World Forum for Harmonization of Vehicle Regulations

Proposal for Supplement 11 to the 01 series of amendments to UN Regulation No. 43 (Safety glazing)

Submitted by the Working Party on General Safety *

Figure 22
Determination of Zone I

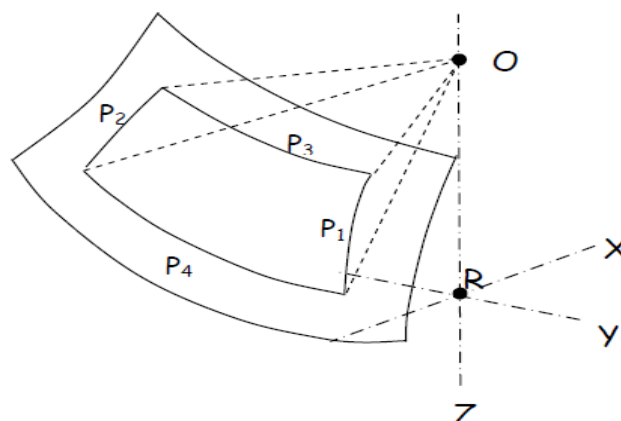
Paragraph 9.2.5.2.3, amend to read and insert a new figure 22:

"9.2.5.2.3. Zone I is the windscreen zone determined by the intersection of the windscreen with the four planes defined below:

In addition, opaque obscuration can be exempted in Zone I. It is the limited areas where it is intended that a sensing device, e.g. a rain-drop detector, rear view mirror or autonomous sensors, will be bonded to the inner side of the windscreen. The opaque obscuration where such devices may be applied is defined in paragraph 9.2.5.2.4. of this annex.

P1 – A vertical plane passing through O and forming an angle of 15° to the left of the

P2 – A vertical plane symmetrical to P1 about the median longitudinal plane of the vehicle.

P3 – A plane passing through the straight Line OQ and forming an angle of 10° above the

P4 – A plane passing through the straight Line OQ and forming an angle of 8° below the

Figure 23

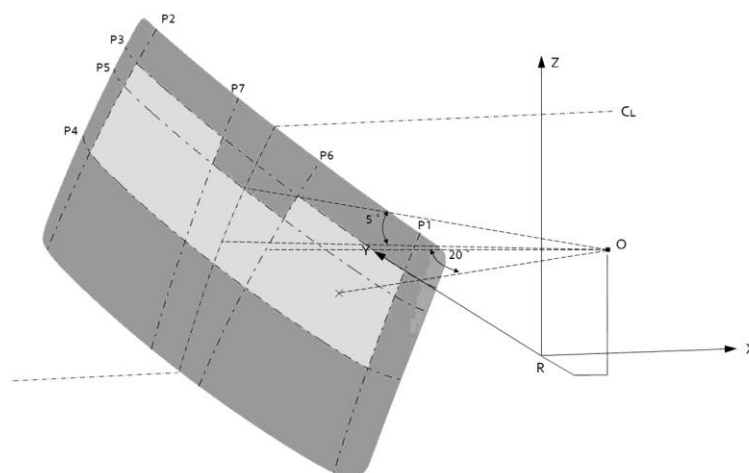
"
 Insert new paragraphs 9.2.5.2.4., to 9.2.5.2.4.1., amend to read and insert a new Figure 23:

"9.2.5.2.4. Determination of the opaque obscuration

P5 – a plane passing through a transverse horizontal line containing O and forming an angle of 5° above the horizontal plane

P6 – a vertical plane passing through O and inclined at 20° to the right of the X axis in the case of left-hand drive vehicles and to the left of the X axis in the case of right-hand drive vehicles.

P7 – a plane symmetrical to P6 in relation to the longitudinal median plane of the vehicles.

9.2.5.2.4.1. Any opaque obscuration bounded downwards by P5 and laterally by P6 and P7.
 (See figure 23)
